## E0027 – Installing Series 3A PCB into SB360

When installing a new series 3A “B” box PCB, Kit EL-37099 into an existing SB-360/MK6 there may be some wiring modifications required.

Location of  
diodes  
D8 & D15

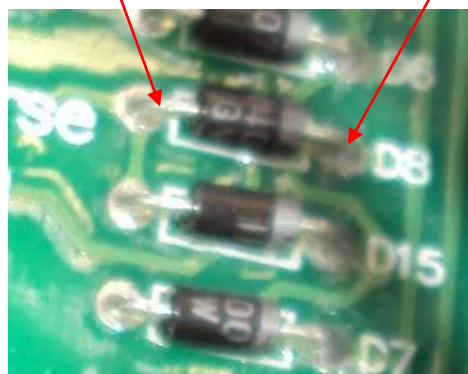
**Action:** Diodes D8 and D15 located near C6 need to be removed from the circuit.

**Note:** Failure to carry out this small modification may result in damaging the rack and pinion system

Cut both ends of the diodes and remove the  
black centre part.

Bypass Connector

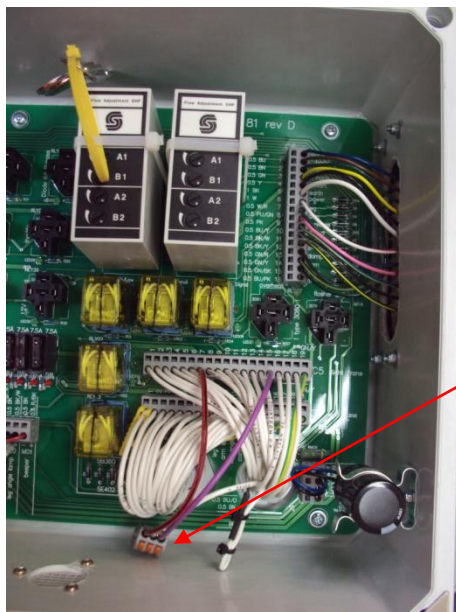
- Remove bypass circuit fitted from C5/7/E to C5/15/E by reinstating wires 7 and 15 to C5/7/E and C5/15/E respectively. An extra kit is required, which includes micro switches etc, which would need to be fitted to the Stabilizer Legs.
- Refer to “E0014 SB360 Stabiliser Down Diode Safety Retrofit System Microswitch” for further details.
